DERRYCLARE PEATLAND REHABILITATION

**Technical Note in Response to Further
Information Required – Galway County
Council (Ref. 23/60)**

Technical Note in Response to Further Information Required (FIR) – Galway County Council (REF. 23/60)

Figure 1 Conceptual cross-section through upland area (based on field observations)

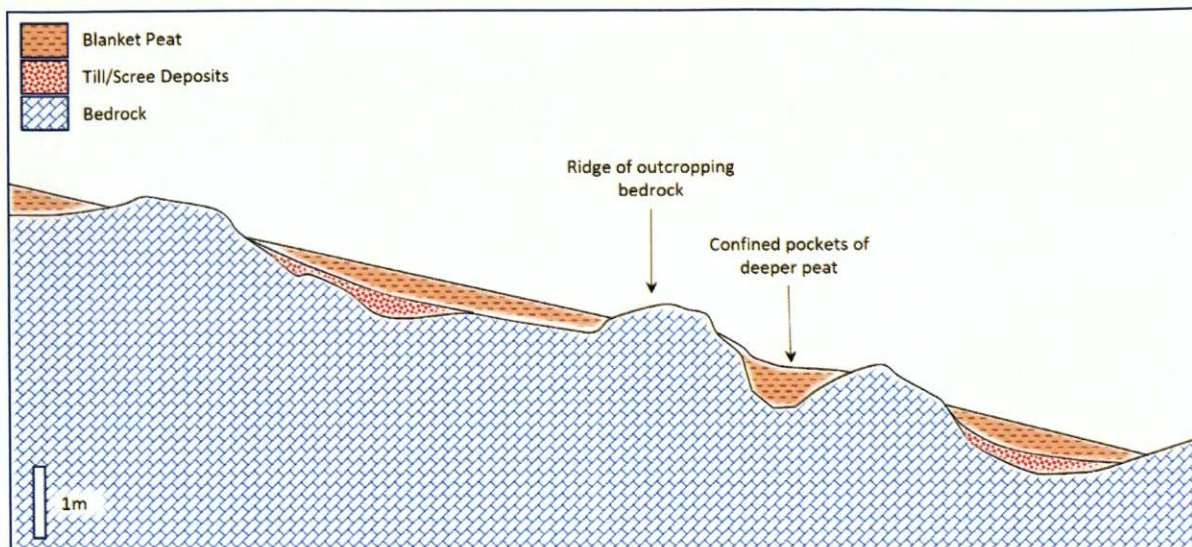
As discussed in Section 4.2 of the Assessment Report, the bedrock outcrop pattern observed during the site walkovers form a series of staggered ridges across the site. These ridges generally form perpendicular to the direction of slope. Their presence is particularly evident in the upland areas to the west of the site. At these locations, the ridges form natural breaks across the slopes, thereby restricting the presence of laterally continuous peat layers. The areas of deeper peat found within the upland areas (such as at PP029) are often confined to pockets representing low points within the underlying bedrock, illustrated in Figure 1. Such terrain may not prevent small isolated peat slippages; however, it is believed that it does significantly reduce the risk of large-scale translational failures within the peat.

With the exception of POI008 (located outside of the harvest block area), evidence of historic peat failures (to include the presence of minor slippages) were not observed during the site walkovers. This is particularly pertinent due to the size of the site and the range of ongoing harvesting operations already in place. The absence of peat failures (with particular emphasis on the survey points presented in Table 2-3) illustrates that the existing peat is not readily susceptible to small-scale slippages or larger-scale translational failures.
